Subject: **Indian Point 3 Nuclear Power Plant**
Docket No. 50-286
Response to Request for Additional Information Concerning
Implementation of the Station Blackout Rule (TAC No. 68557)

**Response to Request for Additional Information
Concerning Implementation of the Station Blackout Rule**

FIGURE 1.

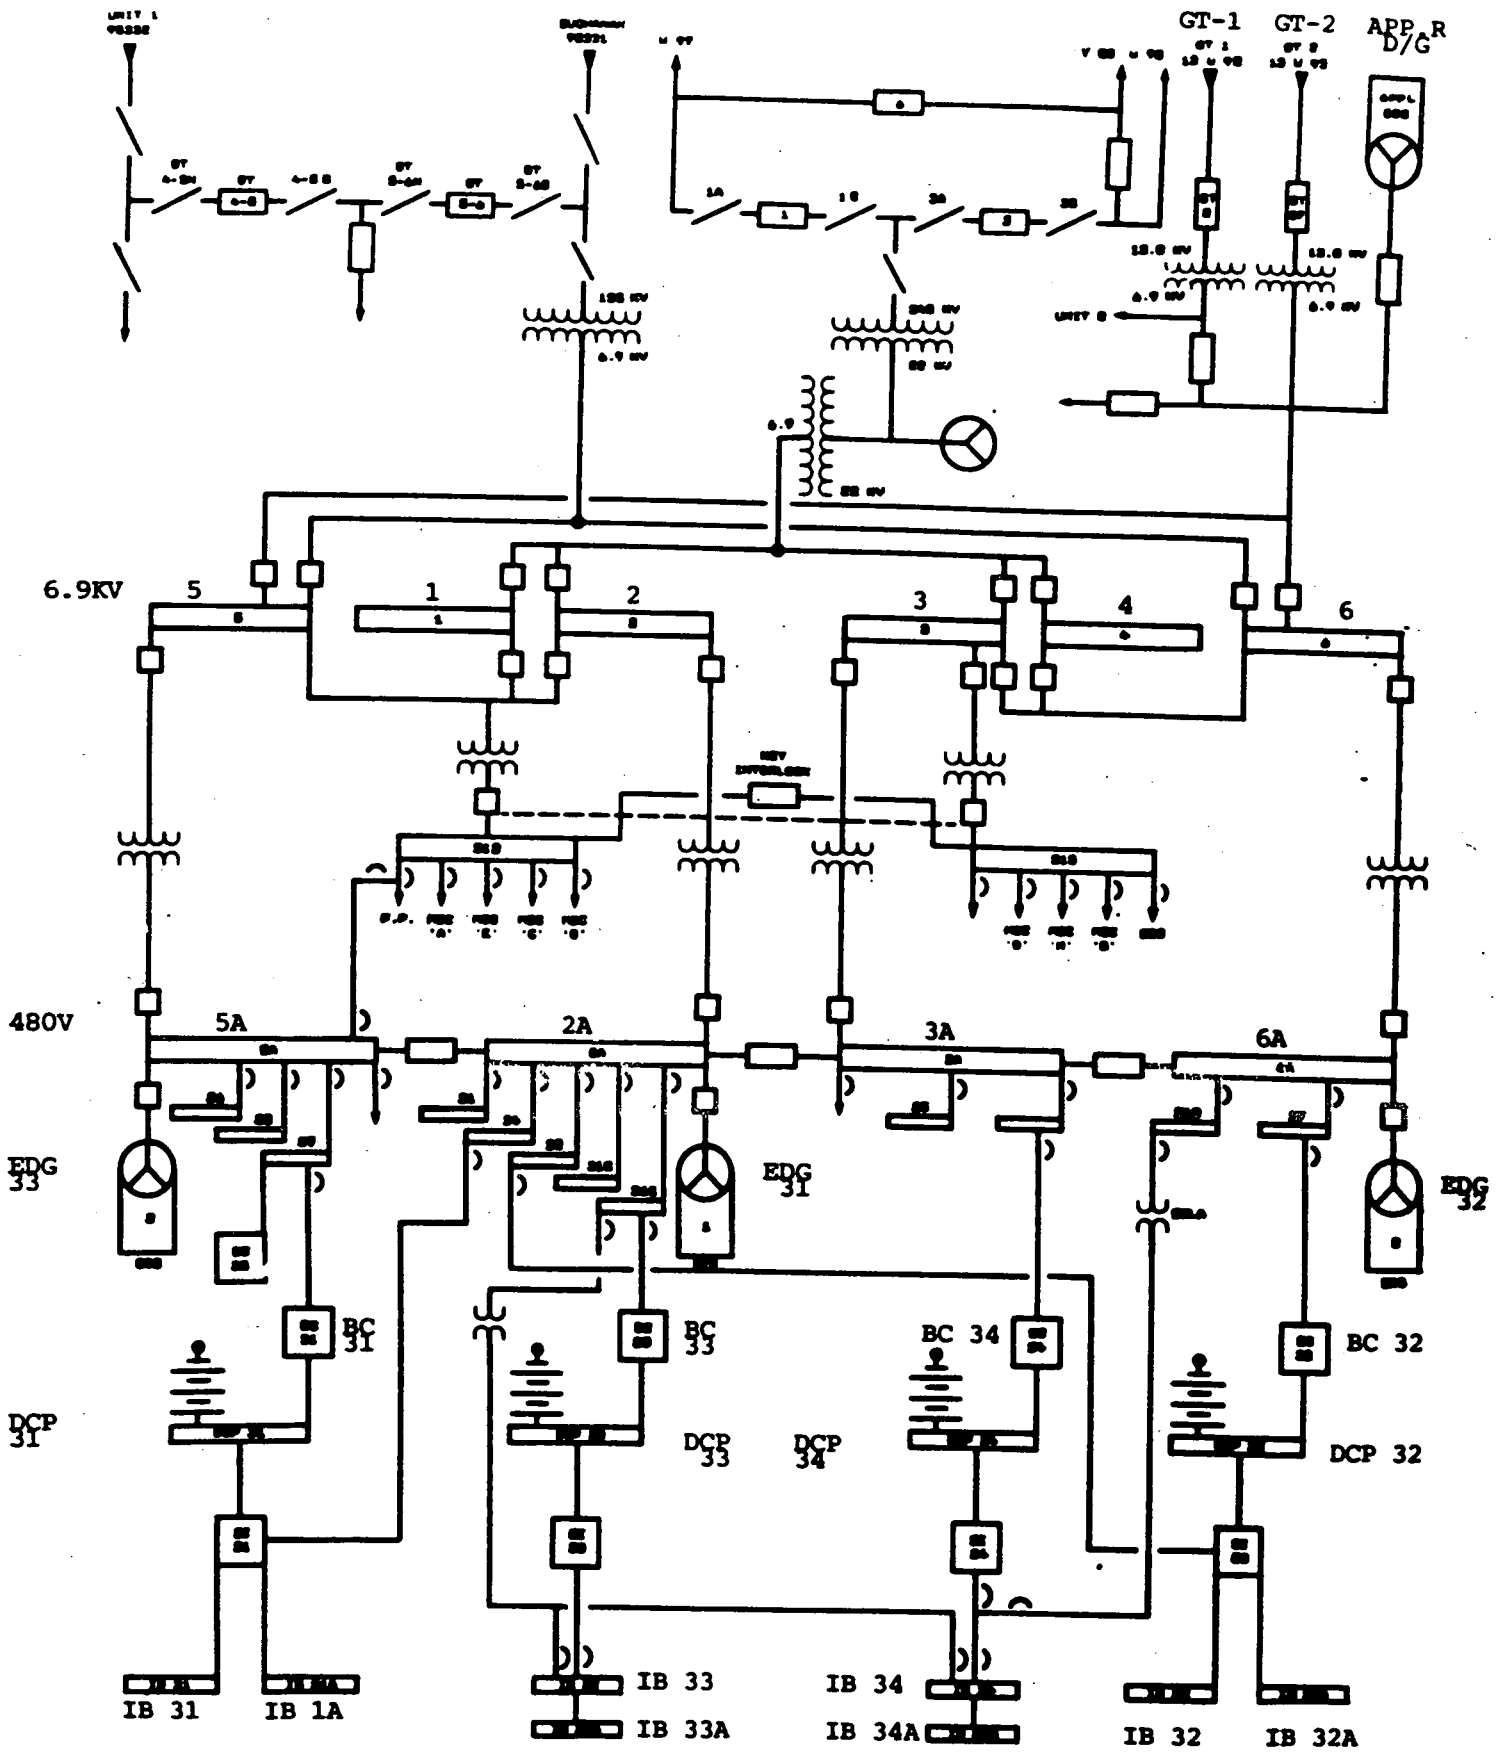
- A. Demonstrate that the use of the Appendix R diesel as an alternate AC power source complies with the guidance of Appendix B of NUMARC 87-00. In particular, address items B.3, B.8 and B.13.**

7. The 6.9kv tie-in from the Appendix R diesel to the gas turbine bus is through the normally open Appendix R diesel generator output breaker. (See Figure 1 for a simplified IP3 electrical distribution schematic.) The Appendix R diesel has no auto-start capability, and must be manually started and loaded onto the gas turbine bus.
